## **Access Compliance Report Public Rights-of-Way** (Curb Ramps)

Intersection ID: N/A Main Street: COSTIGAN LN **Cross Street: BALLANTYNE VILLAGE WY** Location: NW ADA ID: ED926B392A94 Ramp Type: PerpDiag Initial Pass/Fail: Fail **Overall Compliance: No Severity Score:** 17.5

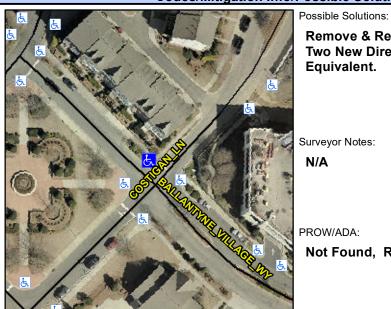
**BALLANTYNE VILLAGE WY** Street 1 Name Stop Condition-Street 2 None Street 2 Name **COSTIGAN LN** Stop Condition-Street 1 StopSign Remove & Replace Curb Ramp With Two New Directional Ramps or Equivalent.

V/ADA:				
Found,	R304.5.1			
24		•	2002.00	
Cost:		\$	3200.00

Comp	liance Description	Data		oliance Description	Data
N/A	Ramp Length (in)	71.5	Yes	Ramp Slope (%)	7.6
No	Ramp Width (in)	33.0	Yes	Ramp XSlope (%)	1.1
N/A	Flare Type LT	N/A	N/A	Flare Type RT	N/A
N/A	Flare Slope LT (%)	N/A	N/A	Flare Slope RT (%)	N/A
N/A	Flare Traversable LT?	N/A	N/A	Flare Traversable RT?	N/A
N/A	Landing Length (in)	N/A	N/A	DWS Provided?	N/A
N/A	Landing Width (in)	N/A	N/A	DWS Contrast?	N/A
N/A	Landing Slope (%)	N/A	N/A	DWS Length (in)	N/A
N/A	Landing X Slope (%)	N/A	N/A	DWS Full Width?	N/A
N/A	Landing Curb? (Y/N)	N/A	N/A	DWS Offset (in)	N/A
N/A	Shared Landing?	N/A			
N/A	Gutter Ponding?	N/A	N/A	Gutter Slope (%)	N/A
N/A	Gutter Lip Ht (in)	N/A	N/A	Gutter X Slope (%)	N/A
N/A	Painted X Walk1?	No	N/A	Painted X Walk2?	No
	X Walk 1 Direction	To SW		X Walk 2 Direction	To SE
N/A	X Walk 1 Width (in)	N/A	N/A	X Walk 2 Width (in)	N/A
	X Walk 1 Slope (%)	2.3		X Walk 2 Slope (%)	1.7
	X Walk 1 X Slope (%)	0.4		X Walk 2 X Slope (%)	0.3
